**PacifiCorp Comments covering
NorthernGrid Economic Study Request - Offshore Wind in Oregon
Submitted: 4/19/2023**

Total Energy Generated

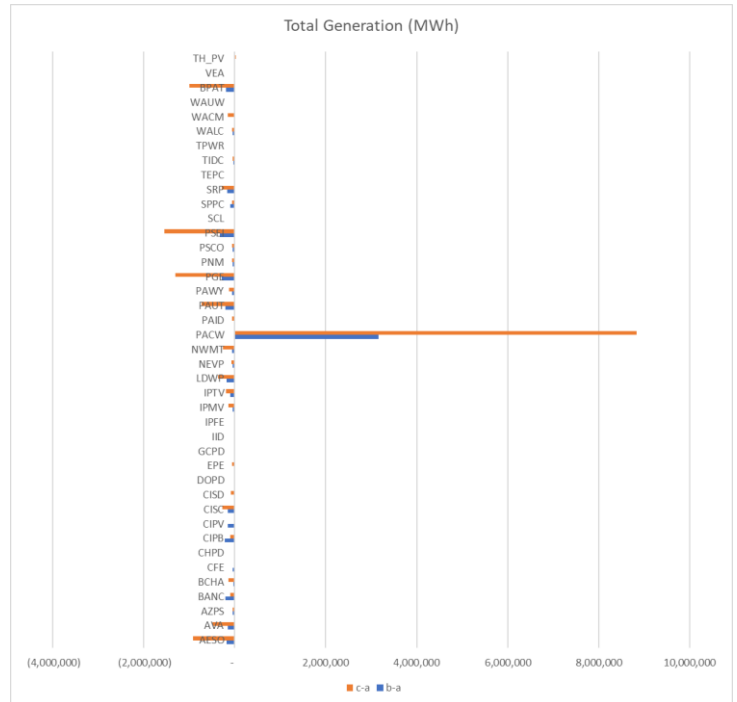
The graph to the right depicts the difference in total energy generated Case 202 minus Case 102, leading to determine where the need is; likely where the 3.0 GW – OSW is displacing thermal resources.

Given that much of the energy generated from the 3 GW – OSW is retained in PACW and given the large volume of generation interconnection requests receive in recent cluster studies, it is likely that the OSW would result in significant stresses on the underlying network.

Accordingly, any transmission solutions should also consider alternatives for transmission expansion from PACW Cluster Studies and other participants interconnection requests.

Spillage

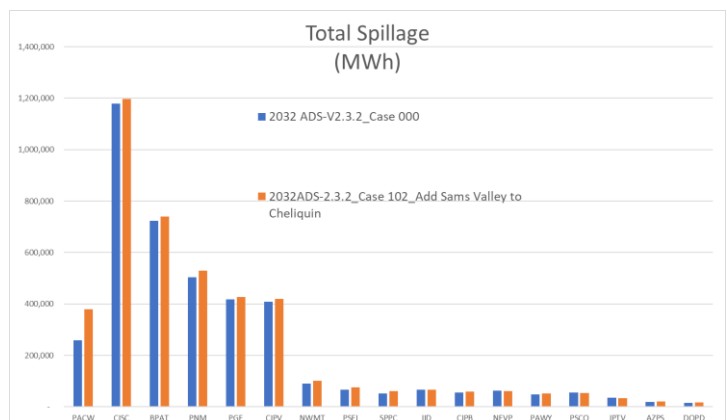
Spillage provides visibility to how the total 3.0 GW – OSW energy is utilized and if not, this is likely due to congested transmission elements (e.g., Transformers, lines, paths)

Figure 21: Sorted carbon-based output, BPAT and PACW

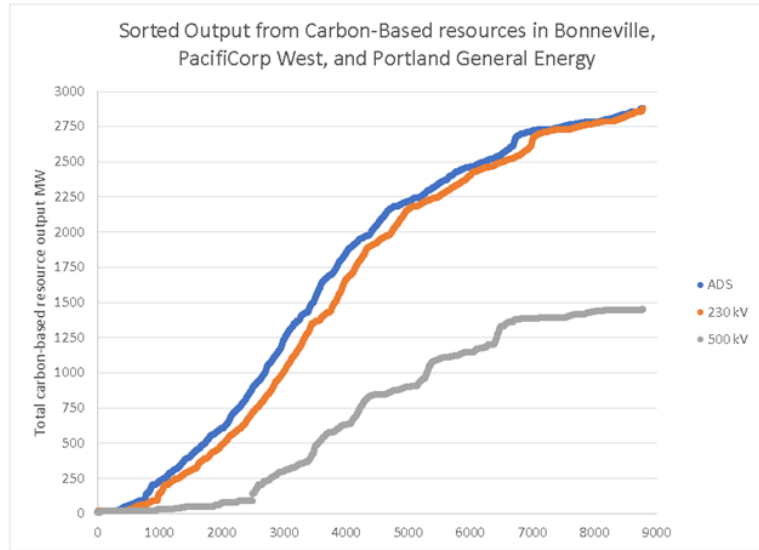
The NorthernGrid Economic Study Report, Figure 21, provides a comparison of carbon-based resource outputs for the base case, 230 kV and 500 kV evaluations, focused on BPAT, PGE and PACW.

As NorthernGrid is comprised of several additional entities that also have thermal generating resources, it would be valuable to also include a comparison that shows the total thermal resource output for the NorthernGrid participants. The following is a summary of thermal - - total (MW) by NorthernGrid member BAA:

- AVA: 836
- PGE: 1685
- IPC: 702
- PSEI: 1619
- BPAT:3900
- PACW: 1113
- PACE: 6531
- NVE:5084
